Z-49
(2011)

PROP. RE-ZONING PLAN FOR:
MILFORD CHURCH OF GOD
3950 HICKS ROAD
AUSTELL, GA 30106

PETITION NO: Z-49

ZONING COMMENTS:

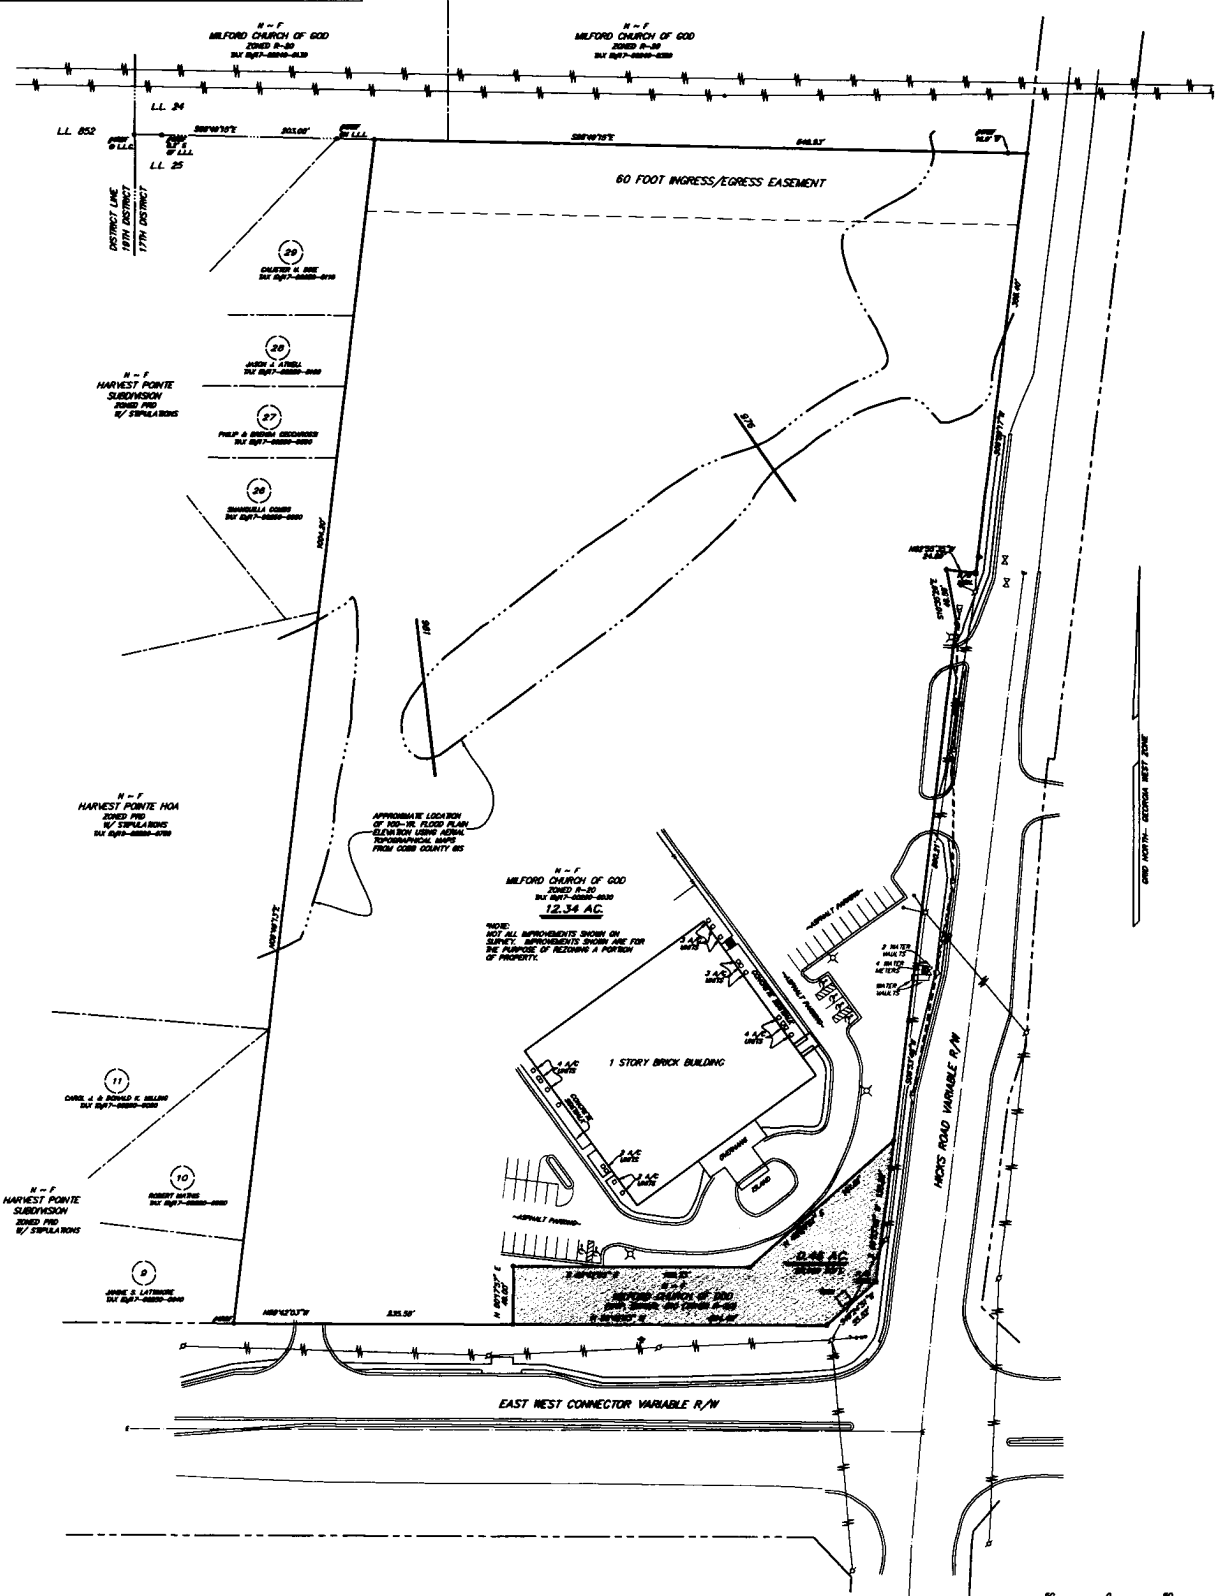
Applicant is proposing to rezone a section of its existing property to the Low Rise Office (LRO) category in order to erect a new digital church sign. While churches are allowed as uses in the R-20 zoning category, signs as proposed by the applicant are not. The overall church acreage is over 12 acres and this application is only to rezone a 20,000 square-foot area toward the front of the church property in order to allow the church to update its sign.

Recommend applicant coordinate with the County prior to development plan approval to ensure compatibility with the Hick Road Sidewalk construction project.

- Site plan dated October 25, 2011, with the District Commissioner approving minor modifications;
- The remaining 12.34 acres of the church site to remain R-20;
- Compliance with the Cobb County Sign Ordinance; and
- DOT comments and recommendations.
